Service Note		
Product	Description:	Service note no.
G-Force, DBMax, M2000, M3000, D22, Fireworx, P2, Finalizer Express, DB2	Display error	SNo-T0154

C232 to be removed

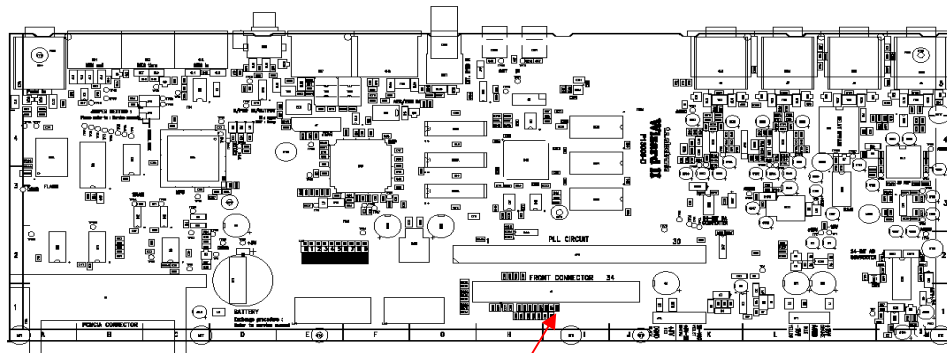
Display errors caused by a loaded CPU clock have been observed. The error can be seen as corrupted characters.

This is for Wizards with mainboard P13006 (M2000, M3000, Fireworx, Finalizer Express, G-Force, DB2, D22, P2 and DBMax)

This problem can be eliminated by removing C232 on the Wizard mainboard.
